Re: DA 0260/2017 Dated 21.07.2017

Comments re Development Application DA026/2017
43 Los Angelos Rd, Swan Bay

Figure 5 - Sight Distance Assessment

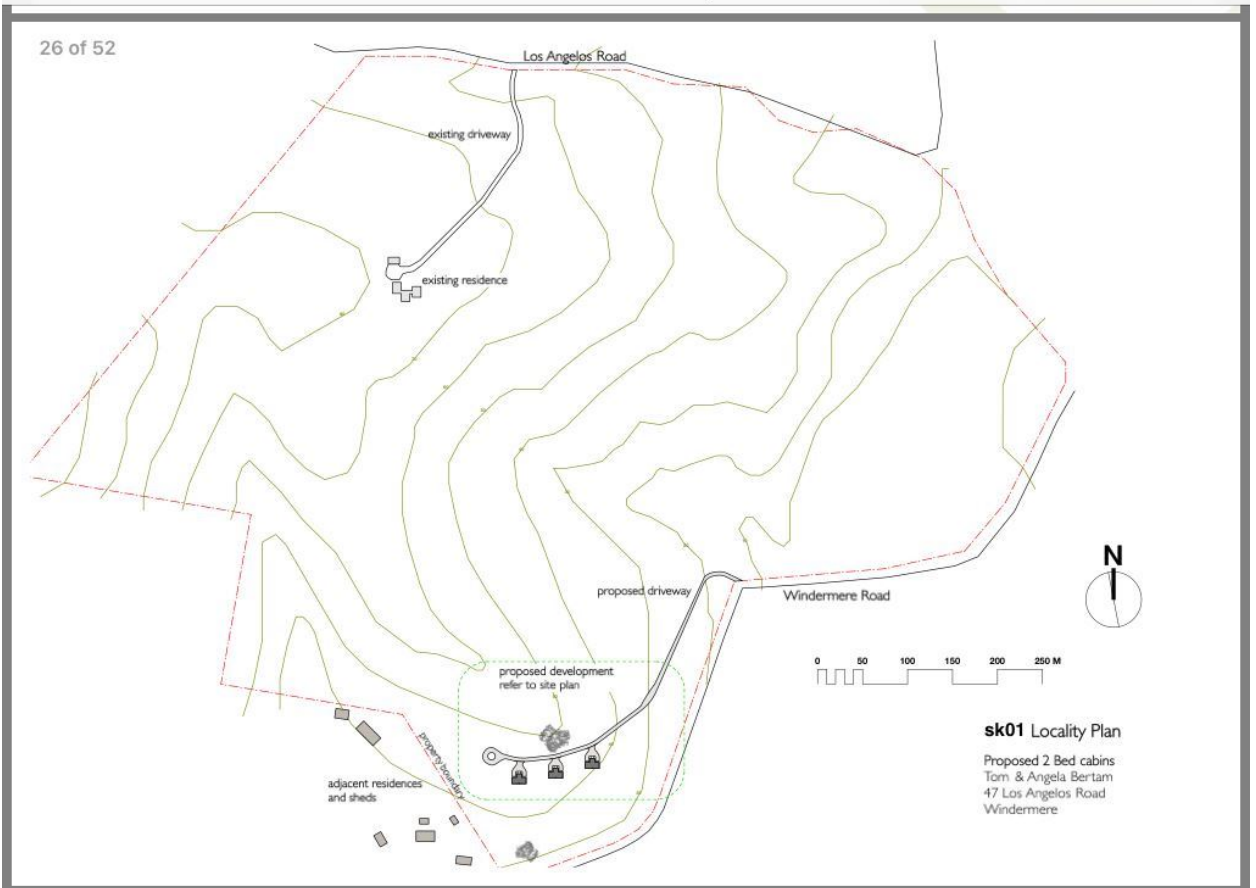
I do have a major concern with the proposed driveway nearer to 98 Windermere road and feel that this will pose unsafe access. I see the traffic management report indicates a line of sight of 90m on the right hand side of the proposed driveway but obviously have not been able to measure this myself due to this being a rather unsafe section of the road at present. As a resident of 27 years and a daily walker, I am unable to walk this section of the road facing oncoming traffic (no path of any kind to allow me to step off the road with my dog) as is the normal and legal way of walking as there is no clear line of sight as there is a bend in the road together with an increase of gradient at this bend. This is the bend where 98 Windermere road is and has always been a problem for motorists when people have to enter or leave 98 Windermere road and the proposed entrance is not far from here.

While the speed limit in this area goes down to 50km/km, in reality this rarely happens and people automatically speed up as they leave this zone leaving Windermere. The speed at the proposed driveway would be at least 60km/hr. No doubt the 50km sign could be shifted to allow for the proposed driveway but I still feel there will be a problem with the line of sight and keeping in mind these units will be catering to tourists who are totally unfamiliar with the roads in the area.

sk01 Locality Plan
Proposed 2 Bed cabins
Tom & Angela Bertam
47 Los Angeles Road
Windermere

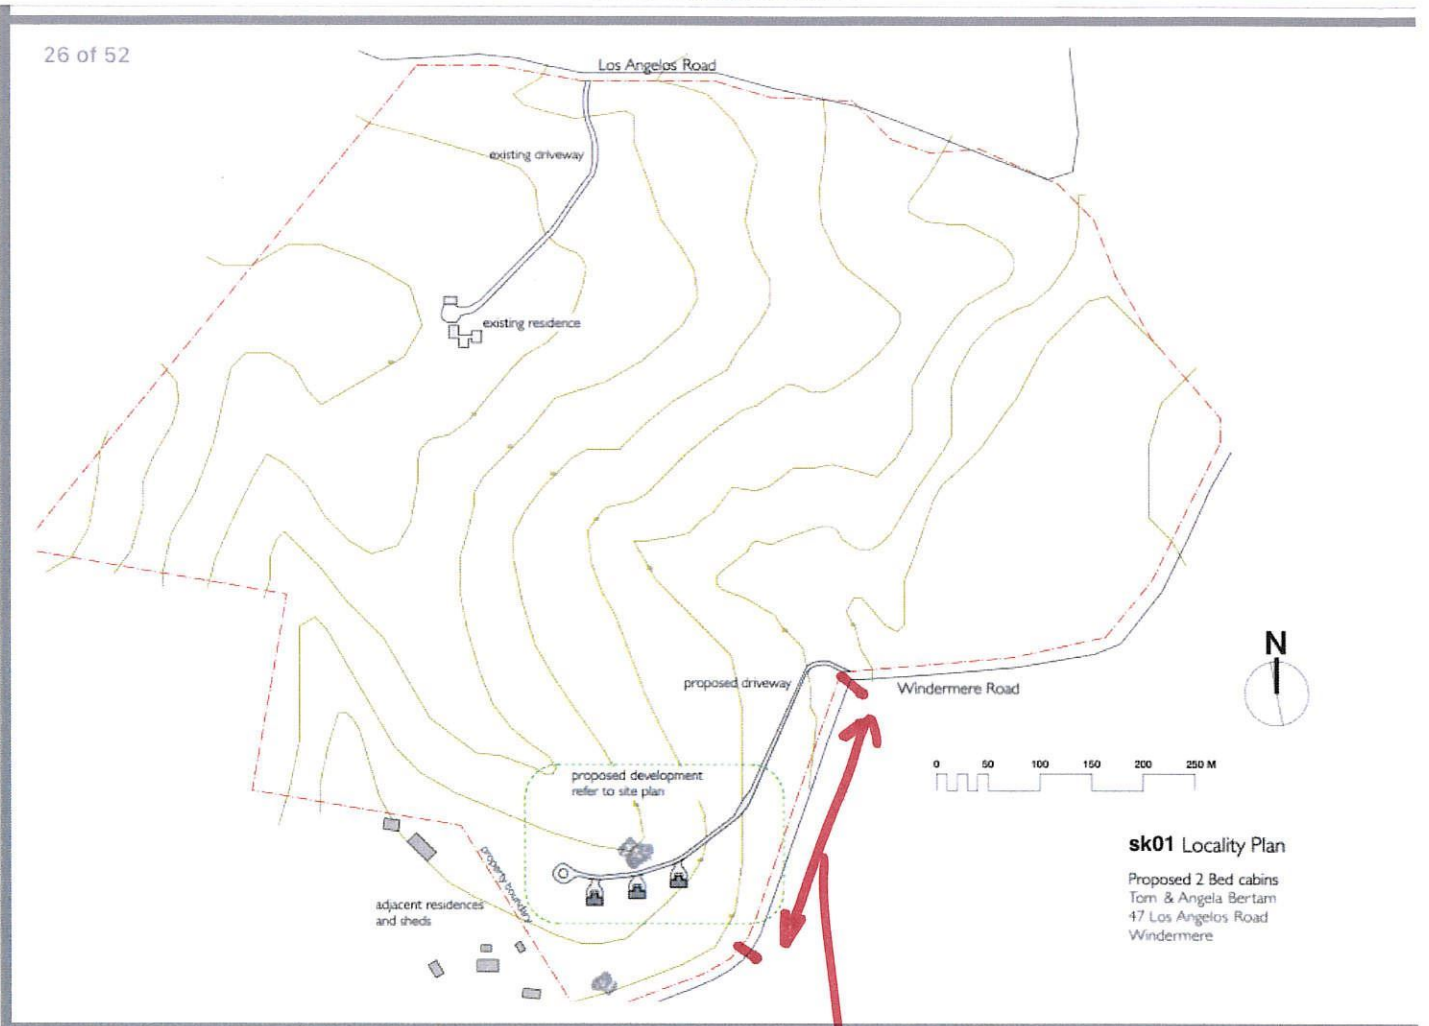
I also wish to add that my attachment to this email indicates my suggestion of the stretch of road that should be considered for the access to the units. If the driveway was situated somewhere around the middle of this straight section of the road, I do not envisage any issue with safety upon entry/exit to the units.

This section of the road has the best visibility because it is straight.
